**City of Portland, Maine – Building or Use Permit Application** 389 Congress Street, 04101, Tel: (207) 874-8703, FAX: 874-8716

RE: Rear Dormer Construction; 129 Emery Street

## BUILDING PERMIT REPORT

DATE: 19 Nov. 97 ADDRESS: 129 Emery St.  
 REASON FOR PERMIT: To Construct dormer  
 BUILDING OWNER: Kris + Cindy Clark  
 CONTRACTOR: Lever Builders  
 PERMIT APPLICANT: Cynthia Mackay APPROVAL: K1, \*8\*9, \*12\*16<sup>14,15</sup>, \*20, \*30 ~~THESE~~  
 USE GROUP R-2 BOCA 1996 CONSTRUCTION TYPE 5 B

Spec Sheet

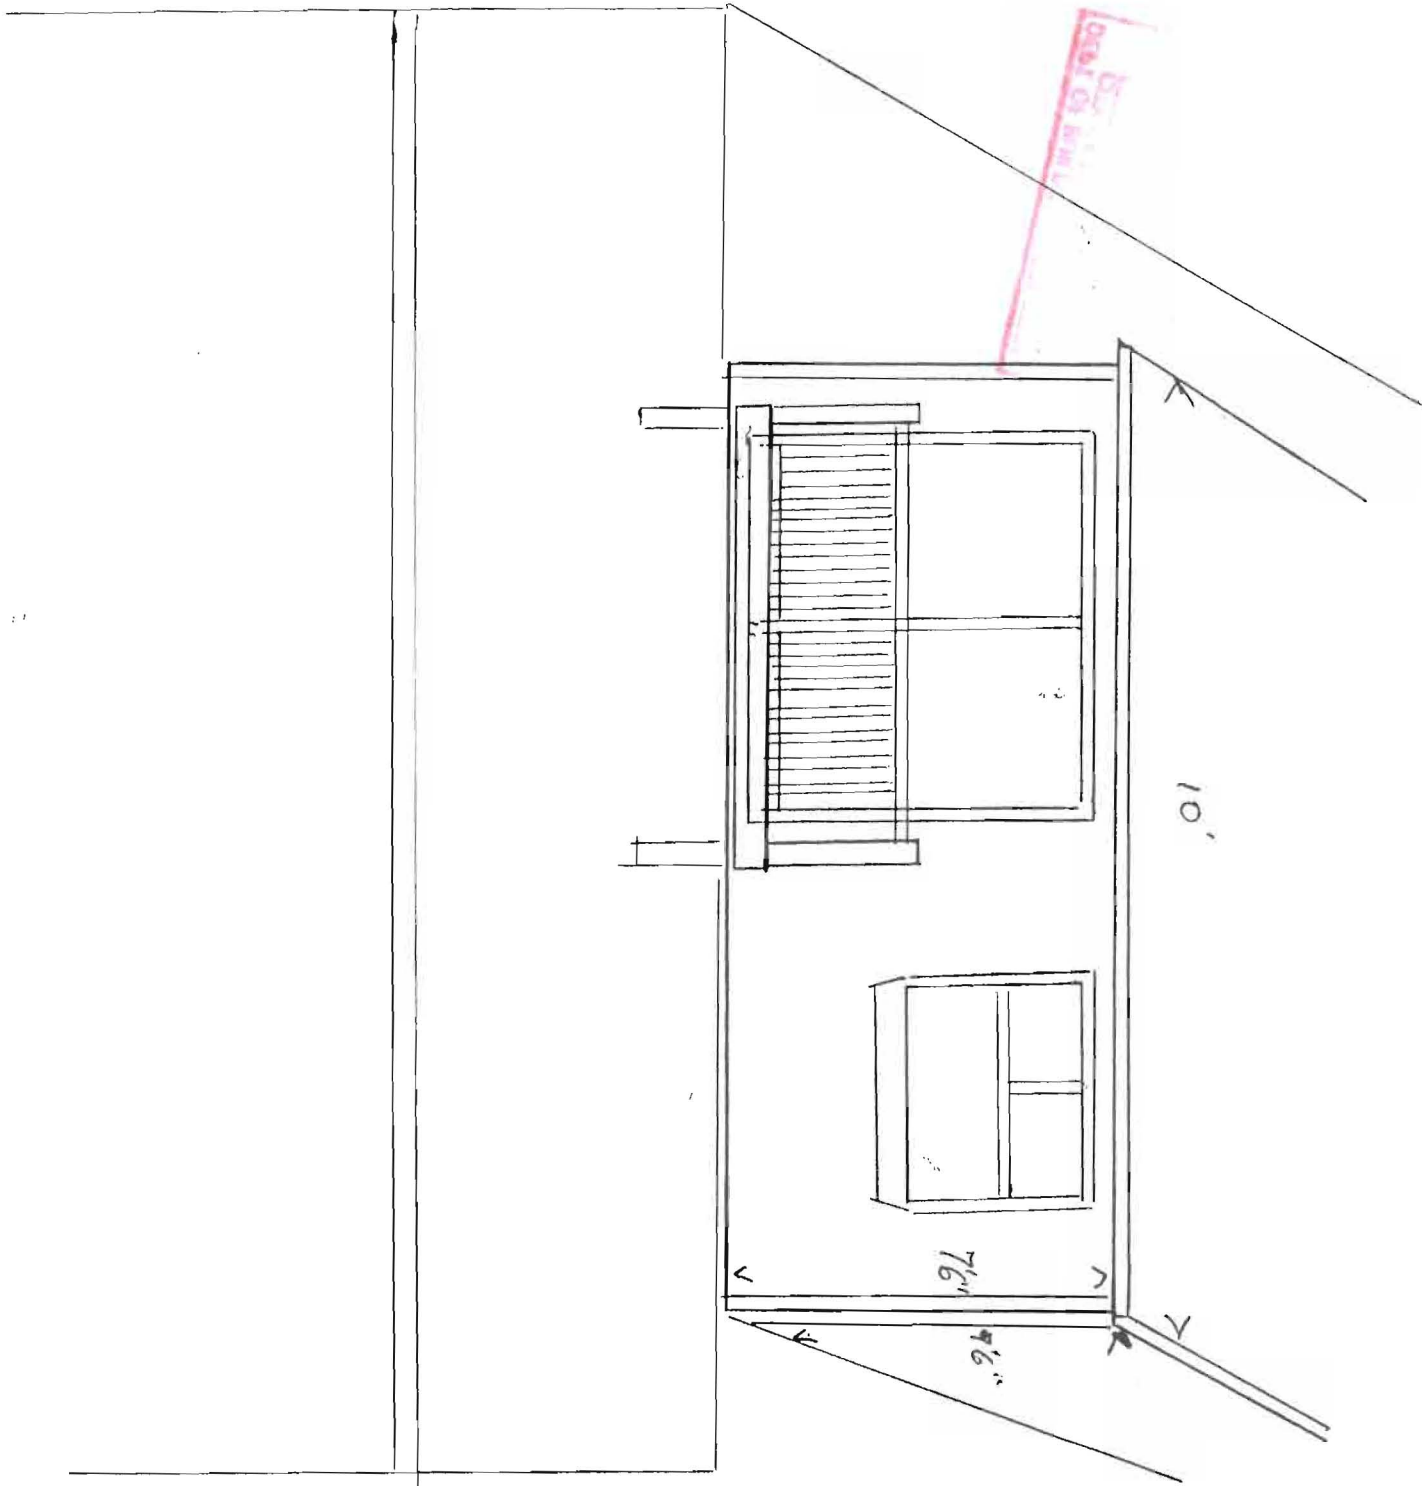
31. Headers For door and window didn't appear on your proposed

32. Plan please submit the sizes of these before work begins

33. Your application also for the proposed dormer shows a foundation,

34. this permit is for dormer only.
